CITY PLAN COMMISSION STAFF REPORT

Ladd School Redevelopment

CD-CPC-2023-00144
Rezoning to UR

Plan Conditions

EXISTING CONDITIONS &
 DEMOLITION PLAN
C100

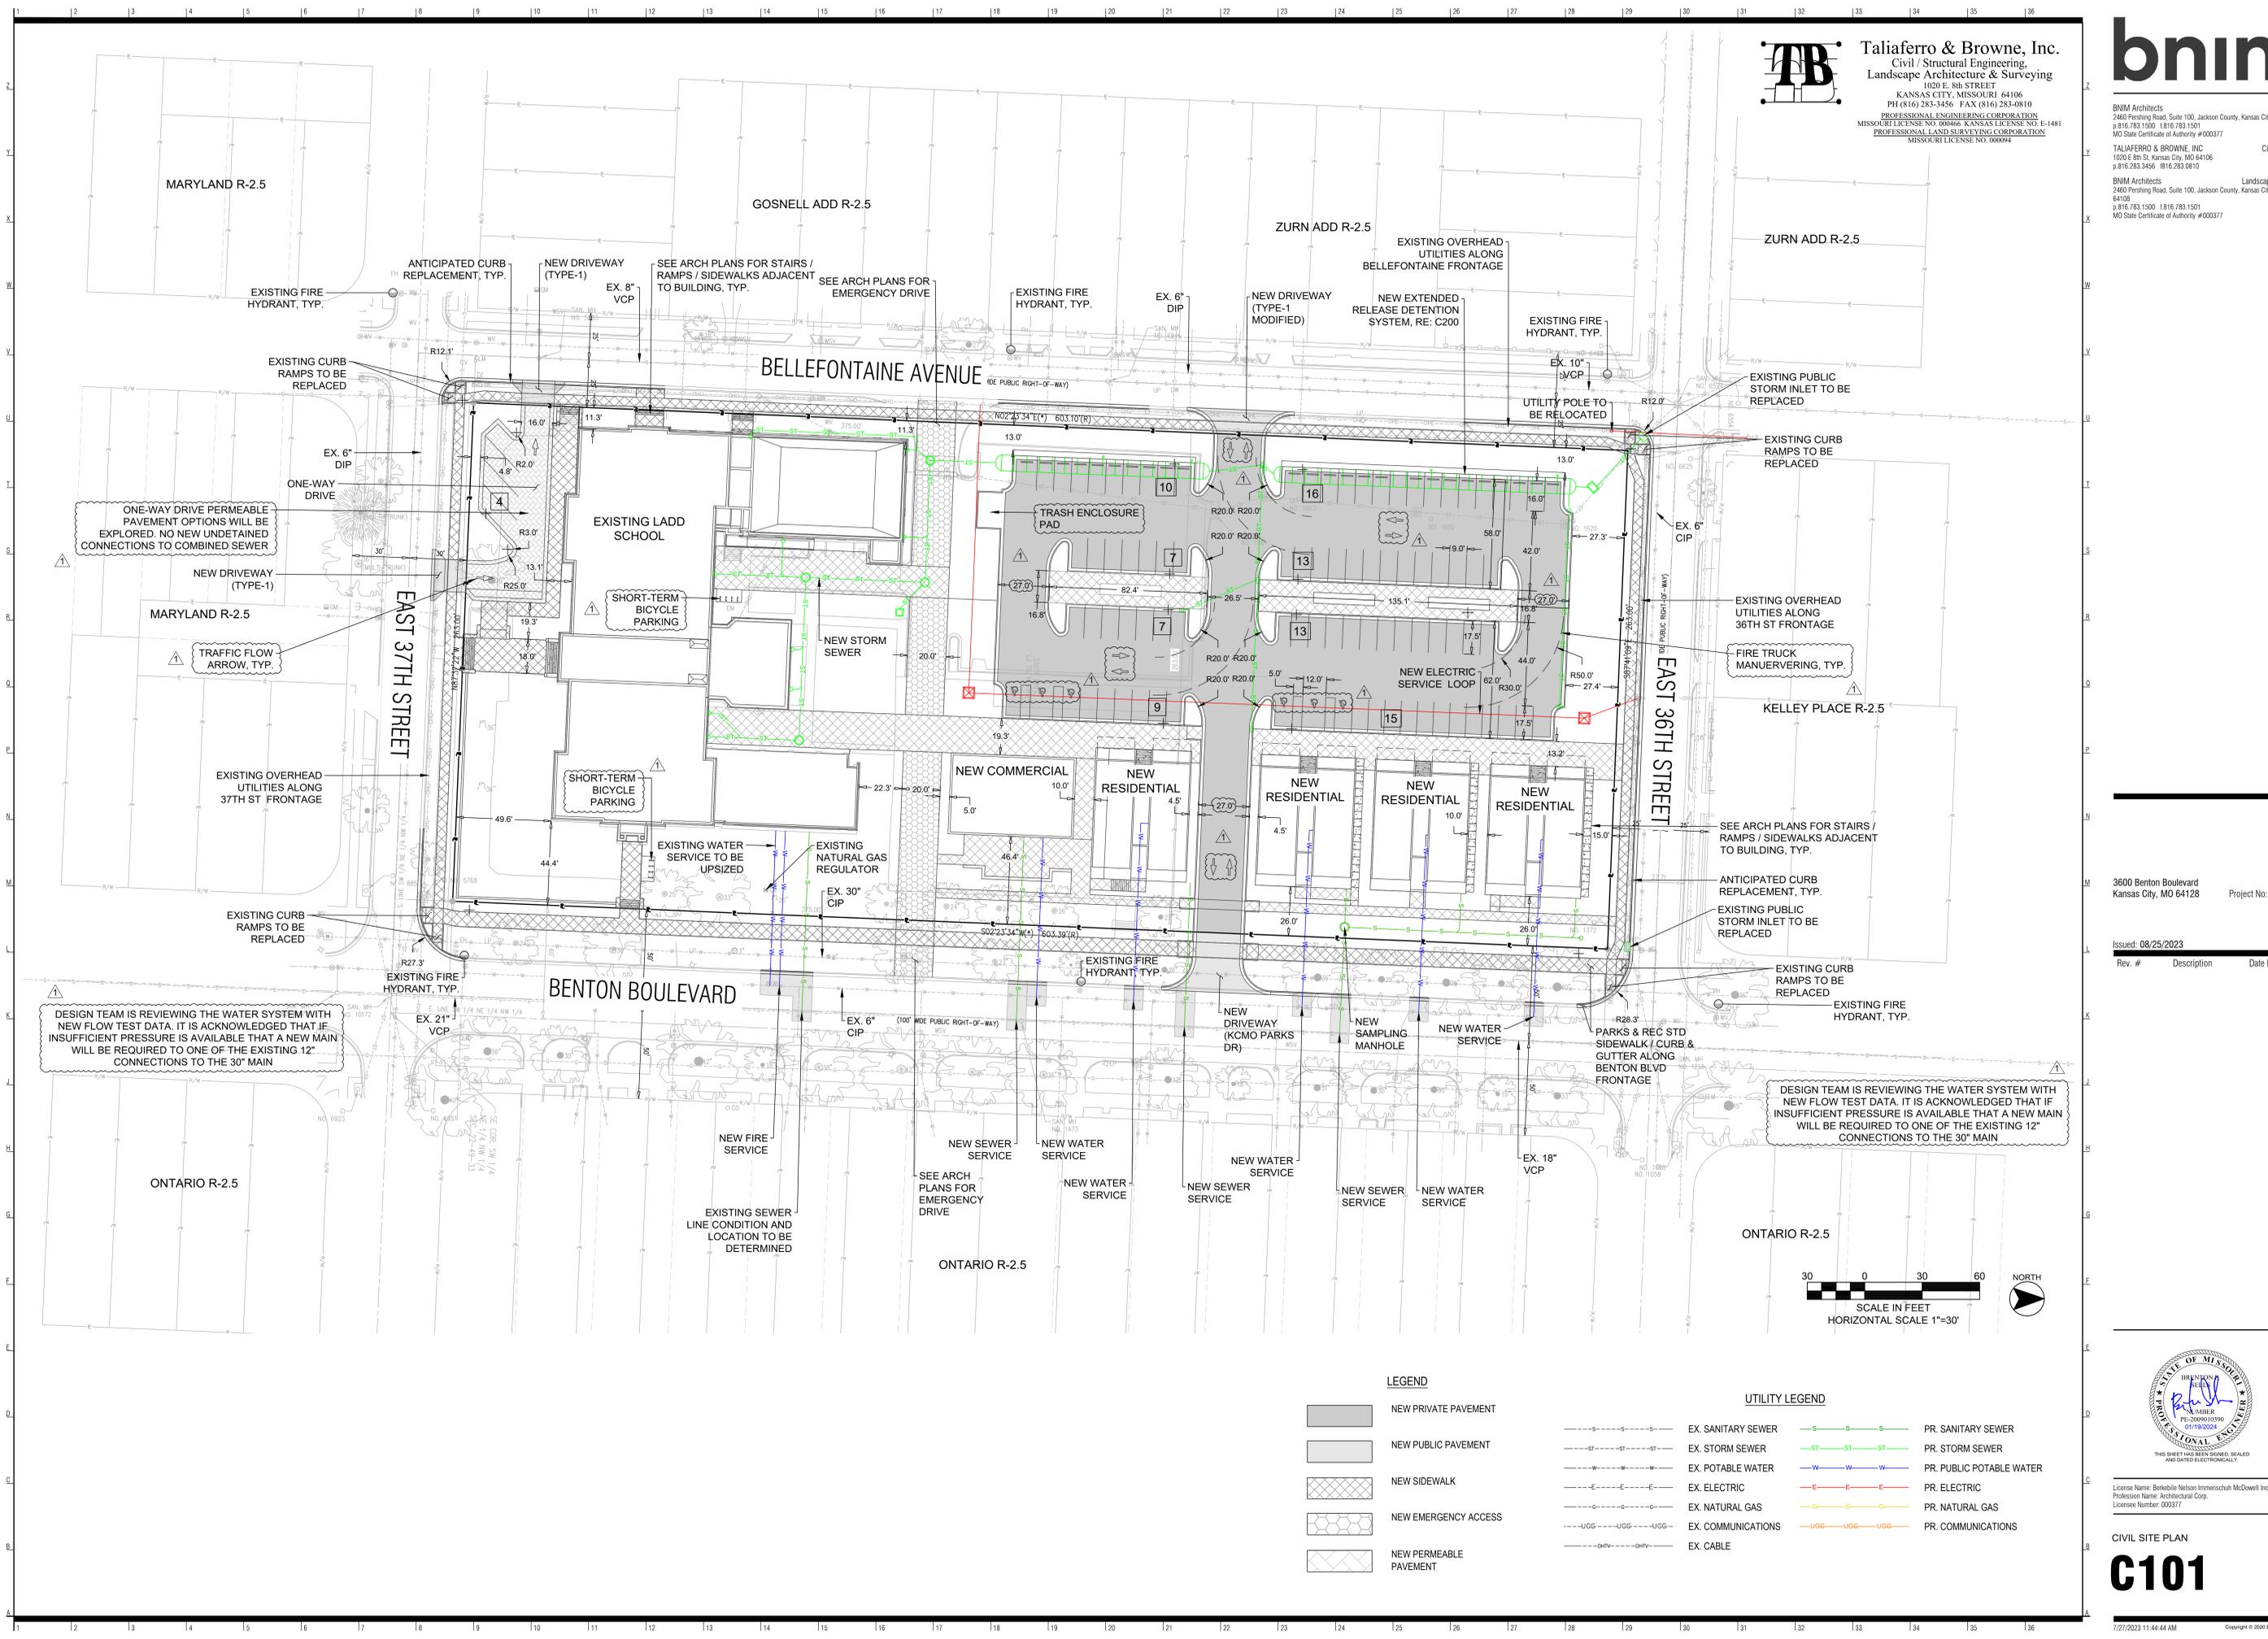
11. The developer shall submit a Storm Drainage analysis from a Missouri-licensed civil engineer to the Land Development Division evaluating proposed improvements and impact to drainage conditions. Since this project is within a "Combined Sewer Overflow" (CSO) district, the project shall be designed to retain rainfall of 1.5 inch depth over the entire site to simulate natural runoff conditions and reduce small storm discharge to the combined sewer system and manage the 10-year storm and 100-year storm per currently adopted APWA standards. The analysis shall be submitted, and the developer shall secure permits to construct any improvements required by the Land Development Division prior to recording the plat.

ONE-WAY DRIVE PERMEABLE PAVEMENT OPTIONS WILL BE EXPLORED. NO NEW UNDETAINED CONNECTIONS TO COMBINED SEWER

CIVIL SITE PLAN

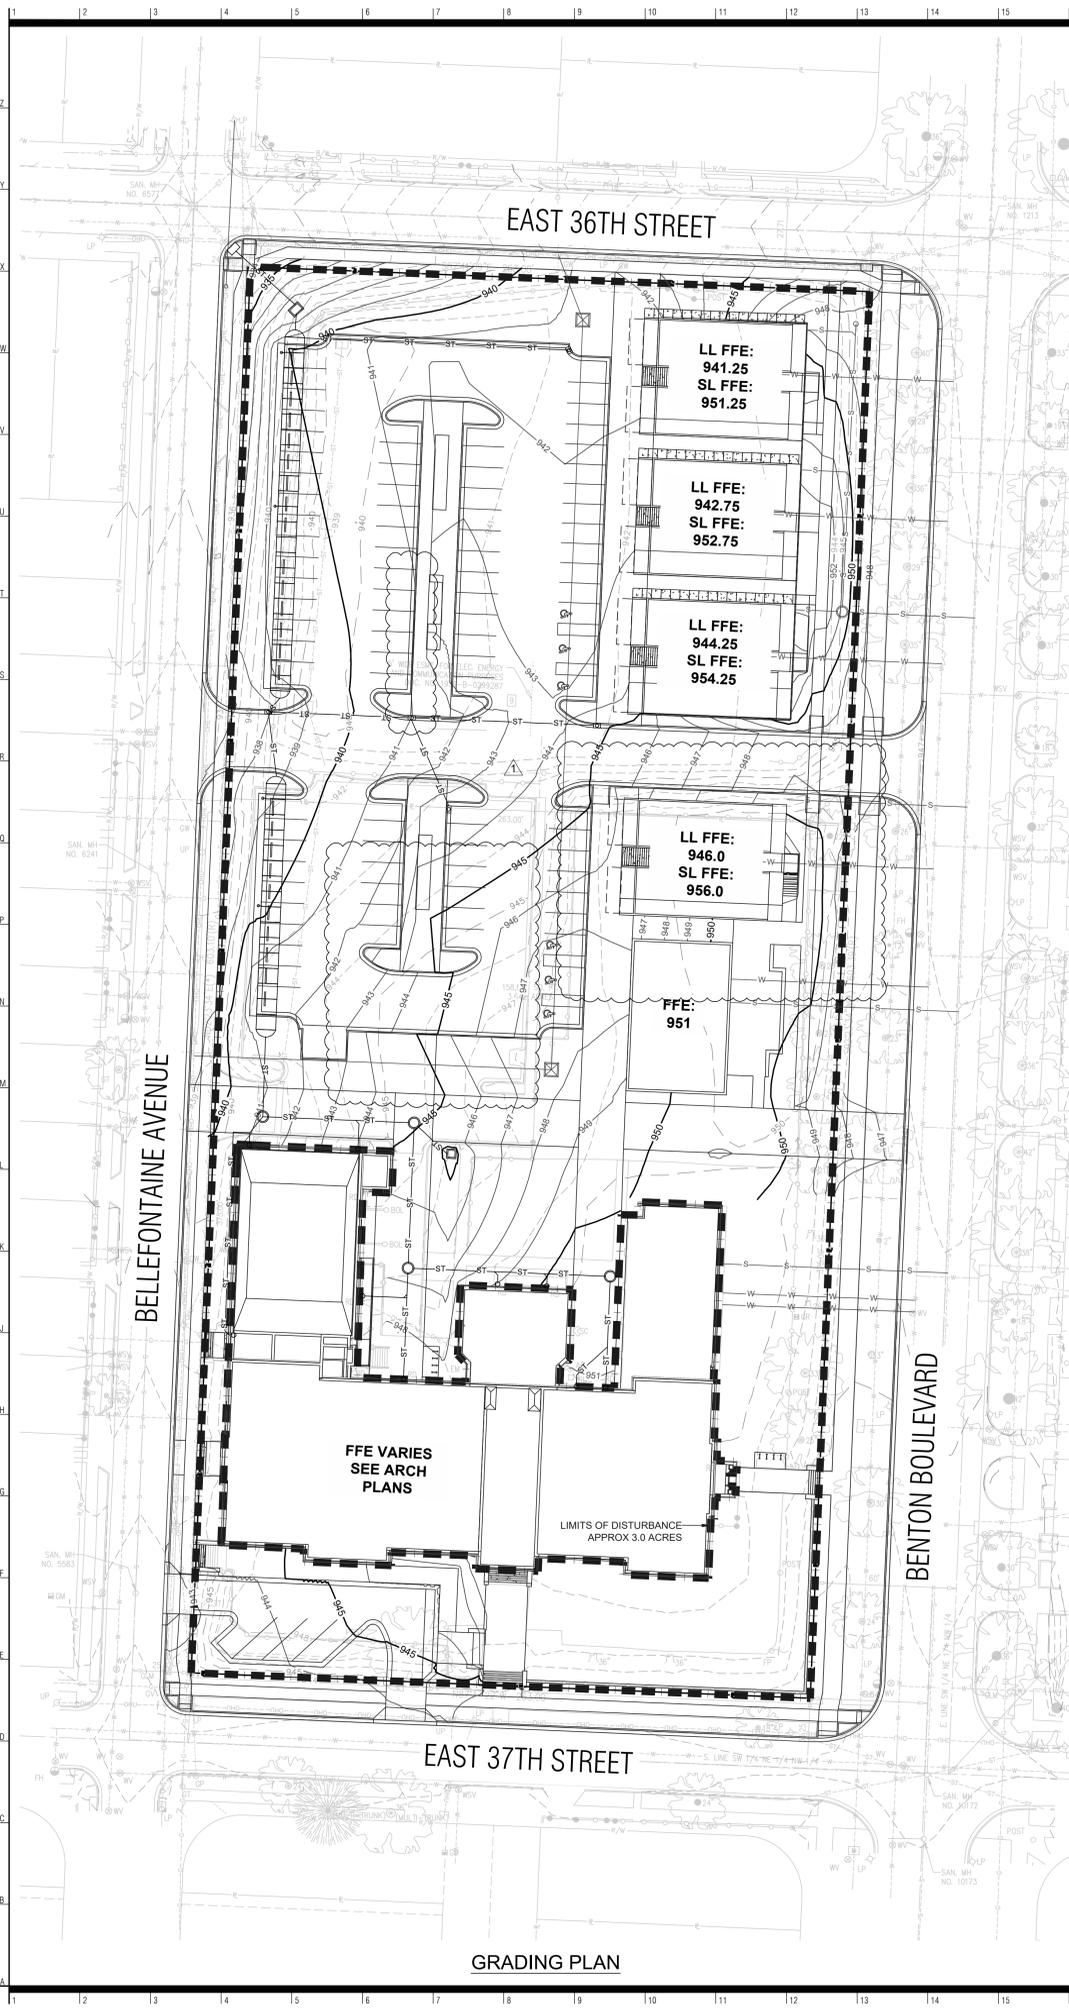
39. Our records indicate that the existing public water distribution main in Benton Blvd. is a 1914 vintage 6" CIP water main. The developer's design engineer will need to confirm through comparative analysis the available capacity of the existing system and new domestic and fire flow demands and provide this analysis to KC Water staff for review. It is anticipated that the 6" public water main in Benton Blvd will need to be upsized and replaced from approximately 36th Street to 37th Street. A parallel 30" transmission main exists in Benton Blvd that can provide additional capacity to the new distribution main, however the 30" main cannot be tapped directly. If replacement and upsizing of the 6" main is confirmed to be required, then the developer shall be responsible for designing and constructing the improvements per KC Water Rules and Regulations. Plans shall be submitted as water main extension drawings prepared by a Missouri PE for review, acceptance and contracts. Rules and Regulations for Water main extensions and Relocations can be found at the following website: (<https://www.kcwater.us/wp-content/uploads/2022/05/2022-Rules-and-Regulations-for-Water-Main-Extensions-Final2.pdf>).

DESIGN TEAM IS REVIEWING THE WATER SYSTEM WITH NEW FLOW TEST DATA. IT IS ACKNOWLEDGED THAT IF INSUFFICIENT PRESSURE IS AVAILABLE THAT A NEW MAIN WILL BE REQUIRED TO ONE OF THE EXISTING 12" CONNECTIONS TO THE 30" MAIN

DESIGN TEAM IS REVIEWING THE WATER SYSTEM WITH NEW FLOW TEST DATA. IT IS ACKNOWLEDGED THAT IF INSUFFICIENT PRESSURE IS AVAILABLE THAT A NEW MAIN WILL BE REQUIRED TO ONE OF THE EXISTING 12" CONNECTIONS TO THE 30" MAIN
